Well Name: NOVEMBER 24	Well Location: T24N / R9W / SEC 28 / NWSW / 36.283051 / -107.799545	County or Parish/State: SAN JUAN / NM
Well Number: 2	Type of Well: OIL WELL	Allottee or Tribe Name:
Lease Number: NMNM12374	Unit or CA Name:	Unit or CA Number:
US Well Number: 300452896100S1	Operator: DUGAN PRODUCTION CORPORATION

Type of Submission: Notice of Intent	Type of Action: Plug and Abandonment
Date Sundry Submitted: 01/03/2025	Time Sundry Submitted: 07:38
Date proposed operation will begin: 01/15/2025

CONDITIONS OF APPROVAL

Notice of Intent - Plug and Abandonment

Planned P & A Schematic

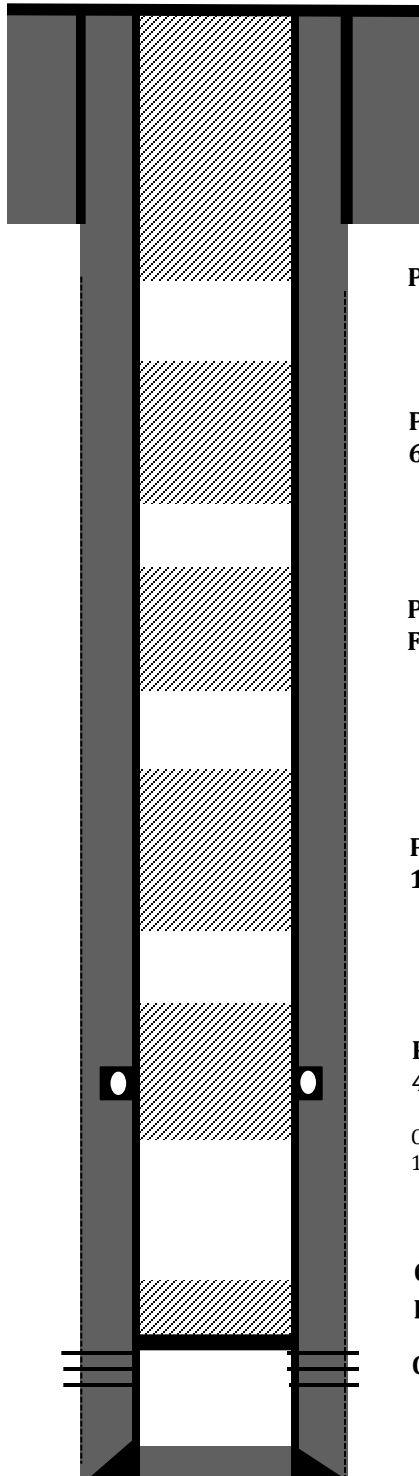
- a. Modify the Plug 1 (Gallup Perforations) TOC to 4750' to account for the BLM geologist's pick for the Gallup (4850'). If plug is tagged, the tag must be at 4800' or higher.

- b. BOC for Plug 2 (Gallup-Manco-DV) may be modified to account for BLM geologist's pick for the Gallup. Plug 2 should cover at a minimum 4090' - 4319'. If plug is tagged, the tag must be at 4140' or higher.

- c. Modify the Plug 3 (Mesaverde-Chacra) BOC to 2650' to account for the BLM geologist's pick for the Cliff House (2600'). Plug 3 should cover at a minimum 1824' – 2650'. If plug is tagged, the tag must be at 1874' or higher.

- d. Modify the Plug 4 (Picture Cliff-Fruitland) TOC to 1080' to account for the BLM geologist's pick for the Fruitland (1180'). Plug 4 should cover at a minimum 1080' - 1580'. If plug is tagged, the tag must be at 1130' or higher.

- e. Modify Plug 5 (Kirtland-Ojo) to account for the BLM geologist's picks for the Kirtland (570') and Ojo Alamo (370') formations. Plug 5 should cover at a minimum 270' - 620'. If plug is tagged, the tag must be at 320' or higher. Plug 5 and Plug 6 may be combined to cover 620' to surface.

Created By	Condition	Condition Date
mkuehling	NMOCD agrees with BLM on formation tops - adjust all plugs top to bottom to accommodate BLM formation tops -Notify NMOCD 24 hours prior to moving on - Monitor string pressures daily - report on subsequent - submit all logs prior to subsequent	1/9/2025
